# Beaches Link and Gore Hill Freeway Connection

## Part B

Response to key stakeholder submissions

November 2021

**Figure B4-1 Koala records within around five kilometres of the survey area, including year of record (DPIE (EES), 2021)**

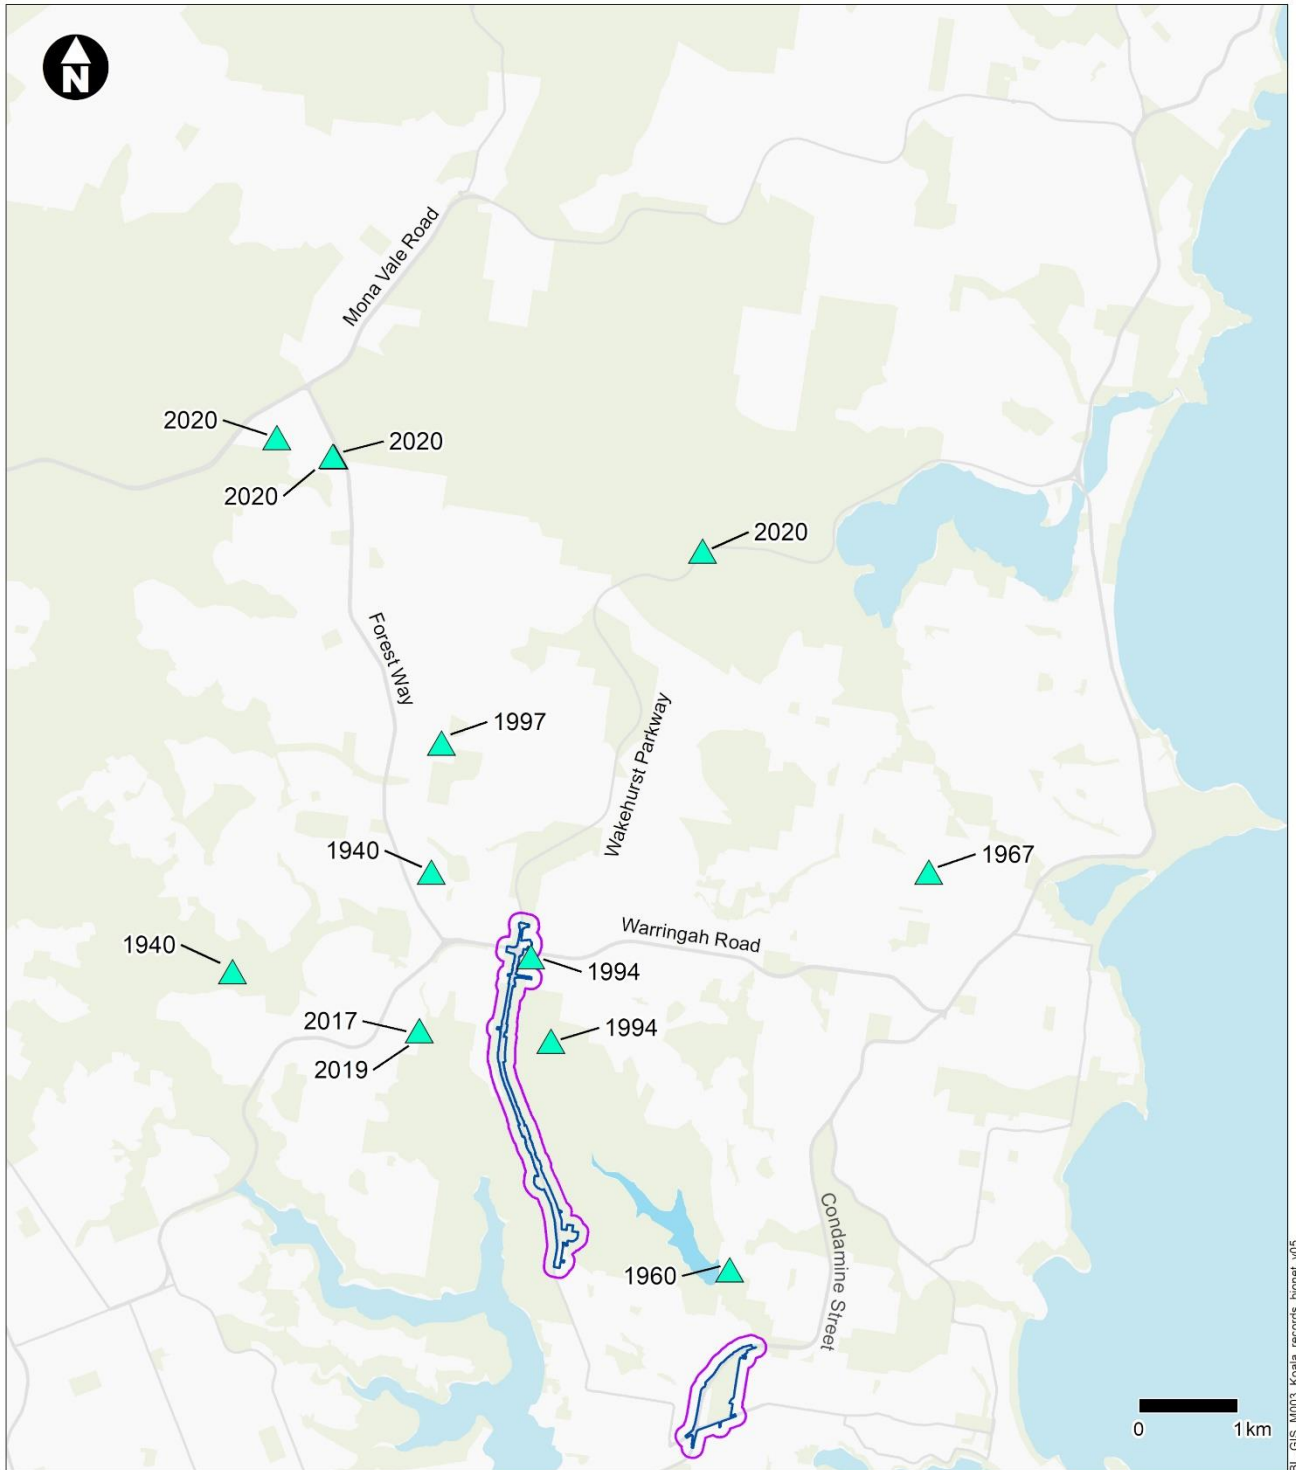
Due to the recent BioNet records of Koalas in the locality, the submissions report needs to consider the likelihood of Koalas using the underpasses and it should include details on specific underpass design features that are known to be required for Koala use.

In consideration of the issue raised by Environment, Energy and Science Group, a supplementary Koala survey and assessment has been carried out and provided as Appendix F3 of this submissions report. Koala surveys were carried out over four days and three nights in June and July 2021 within the subject land (ie construction footprint) plus a 100 metre buffer in areas of potential Koala habitat at Wakehurst Parkway and Burnt Bridge Creek. Targeted surveys were carried out using three survey techniques:

Koalas have historically been recorded in very low numbers in the Northern Beaches local government area. BioNet database (NSW DPIE (EES), 2021) records show a total of 10 records of the species within around five kilometres of the subject land at Wakehurst Parkway and Burnt Bridge Creek. An additional three records of the species from 2020 are located just over five kilometres from the subject land and are considered relevant to this discussion. All 13 records are mapped in Figure B4-1 and a summary of the records is provided in Table B4-5 (presented in order of distance from subject land).

**Figure B4-6 Area of groundwater dependent ecosystem assessment (update to Figure 3-11 of Appendix S (Technical working paper: Biodiversity development assessment report))**

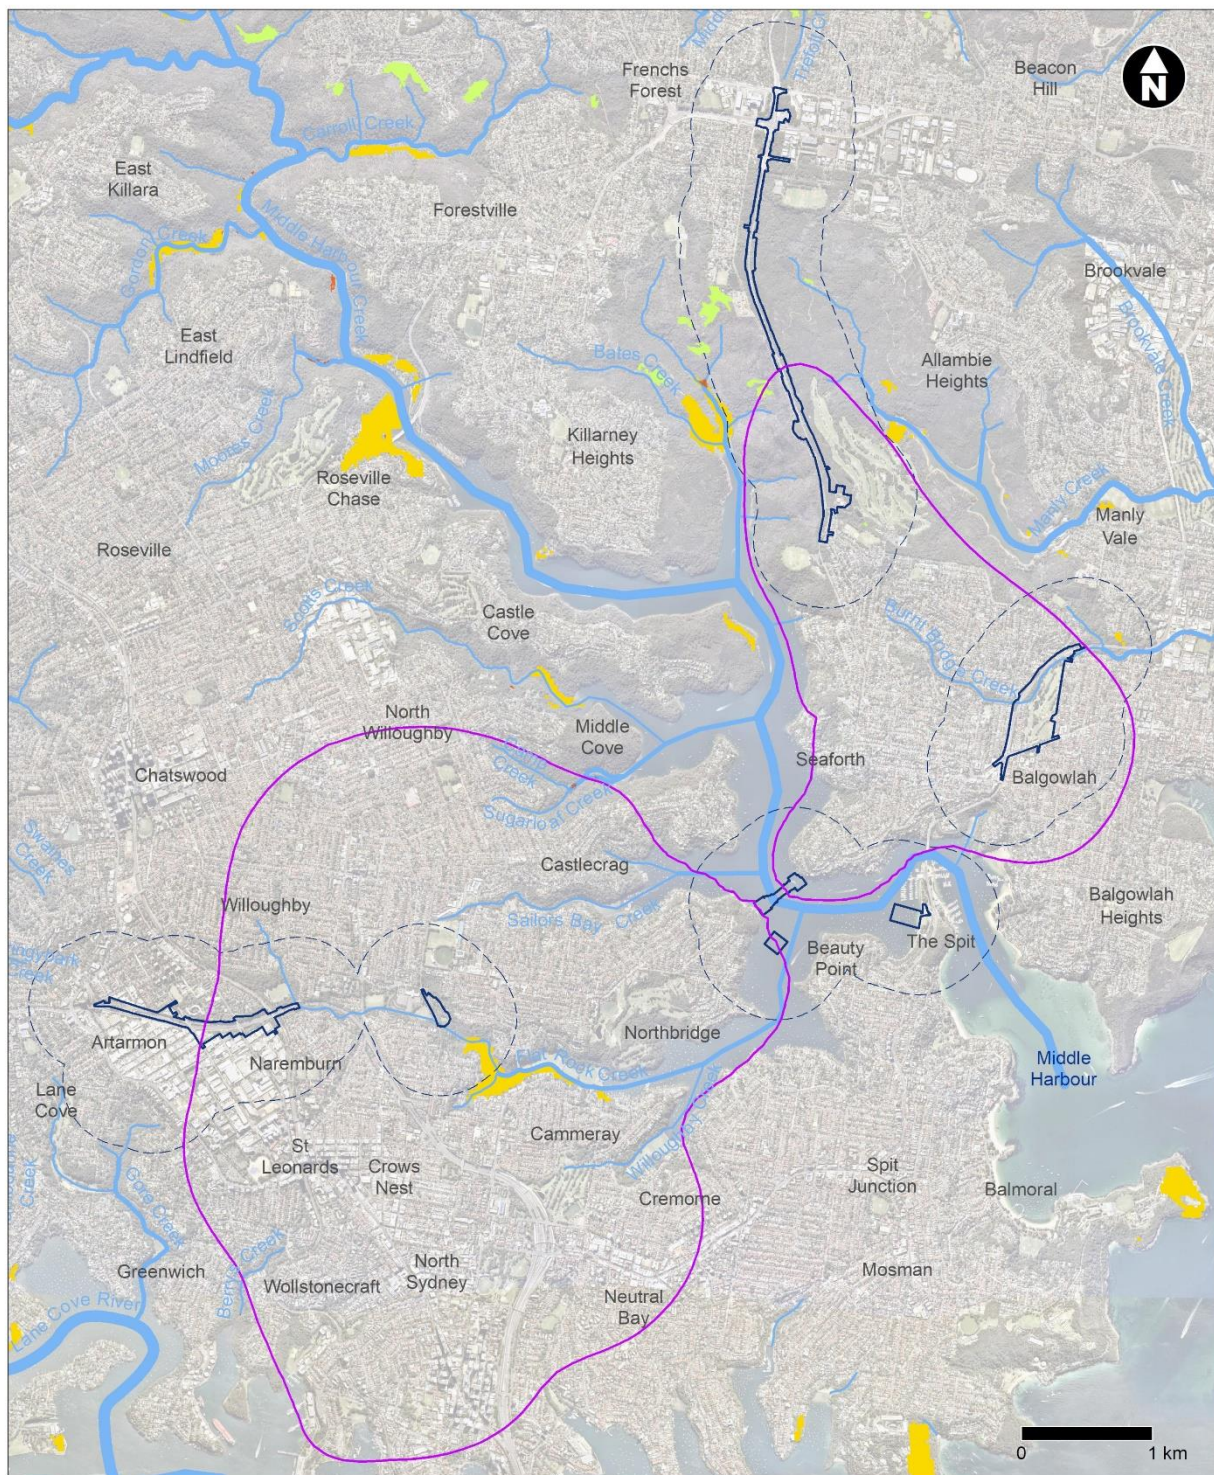
The term "locality" is not defined in Appendix S (Technical working paper: Biodiversity development assessment report), though used throughout in different contexts. It is not explained how the extent of the "locality" was determined for the purposes of identifying groundwater dependent ecosystems that need to be considered for potential impacts of the project.

The term 'locality' is used to describe the assessment area (ie within 500 metres of the subject land). The assessment area used in the biodiversity assessment is defined in Section 2.2.2 and shown in Figure 2-1 of Appendix S (Technical working paper: Biodiversity development assessment report).

However, for the purpose of identifying groundwater dependent ecosystems in Appendix S (Technical working paper: Biodiversity development assessment report), the assessment area/locality not only included all areas within 500 metres of the subject land (construction footprint), but also any additional areas potentially impacted by water table drawdown, based on the drawdown contours included in Section 6.2.2 of Appendix N (Technical working paper: Groundwater). The assessment area/locality for the purposes of the groundwater dependent ecosystems assessment is shown in Figure B4-6 below (which is an updated version of Figure 3-11 from Appendix S (Technical working paper: Biodiversity development assessment report)).

**Figure B4-7 Vegetation types of groundwater dependent ecosystems mapped by Bureau of Meteorology (2018) around Flat Rock Creek**

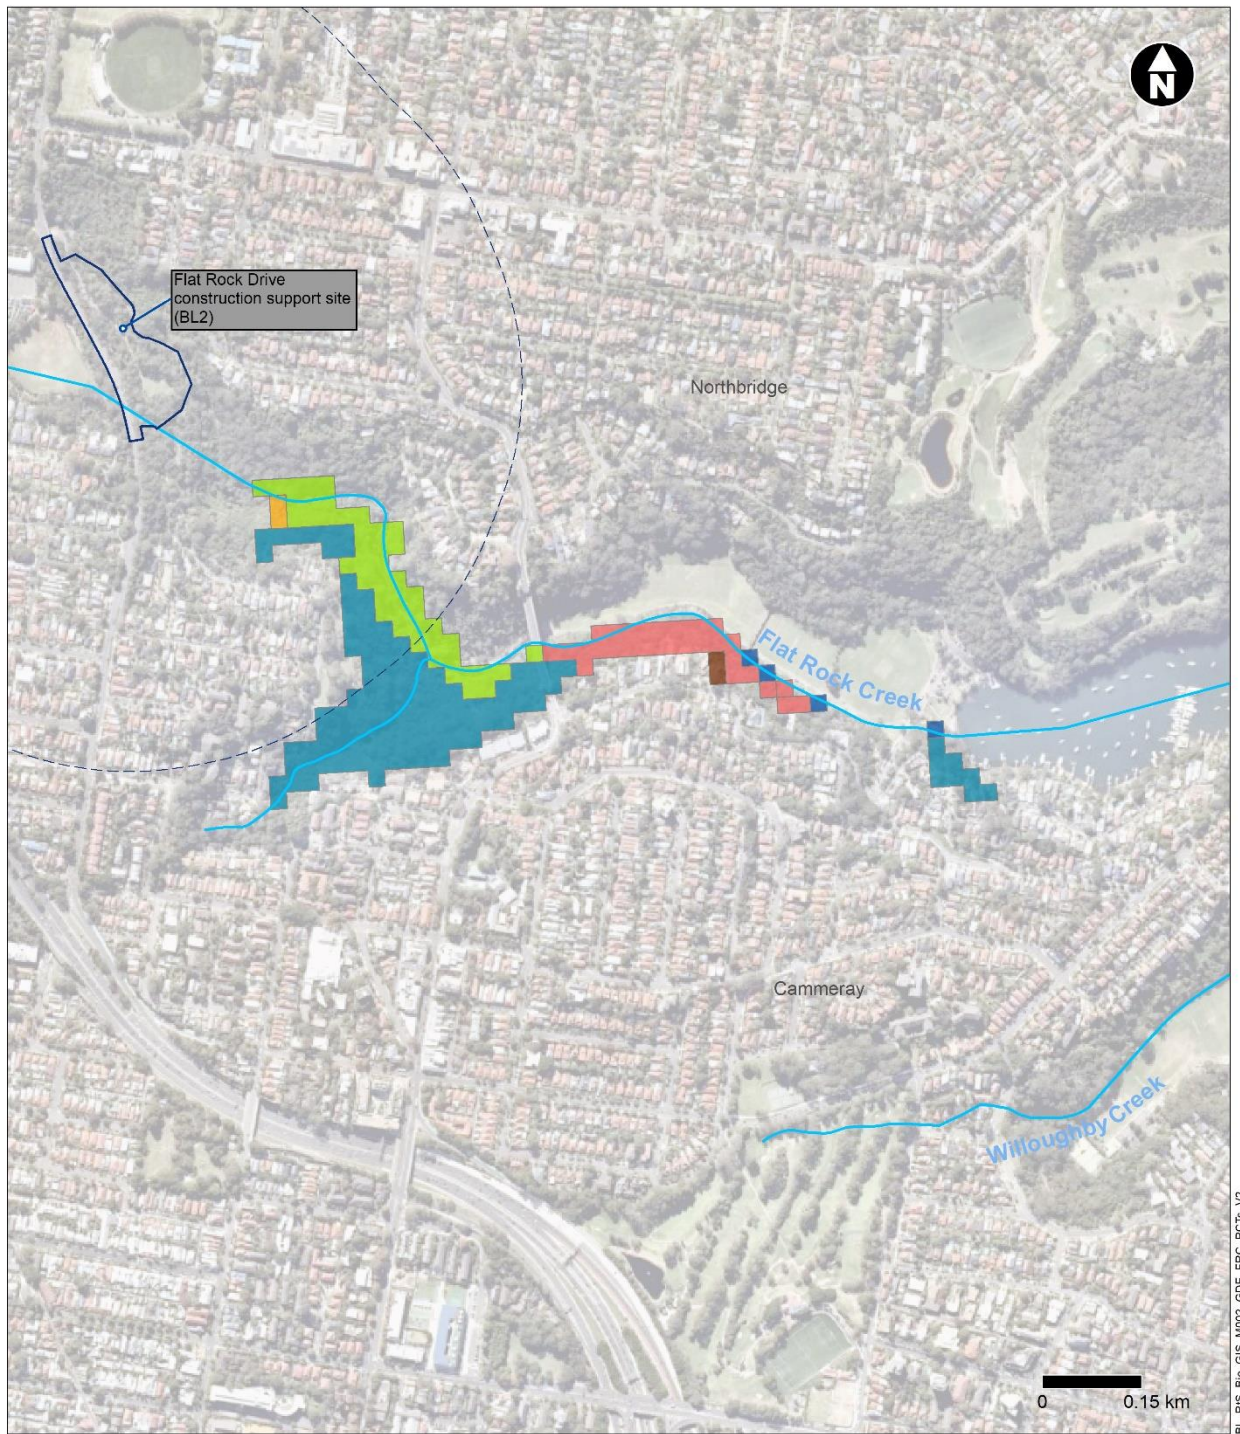
For the Flat Rock Creek Reserve/Munro Reserve, Appendix S (Technical working paper: Biodiversity development assessment report) has omitted to include the following groundwater dependent ecosystems reliant on subsurface presence of groundwater as identified by the Bureau of Meteorology (BOM) (2018): Vegetation classified as Coastal Sandstone Plateau Heath, Estuarine Fringe Forest and Illawarra Gully Wet Forest.

It is acknowledged that the groundwater dependent ecosystems mapped around Flat Rock Creek include small areas of Coastal Sandstone Plateau Heath, Estuarine Fringe Forest and Illawarra Gully Wet Forest. These areas are mapped as very small patches within and along the edges of the larger patches of Coastal Sandstone Gully Forest, Sandstone Riparian Scrub and Coastal Sand Forest mapped at this location as shown in Figure B4-7 below.
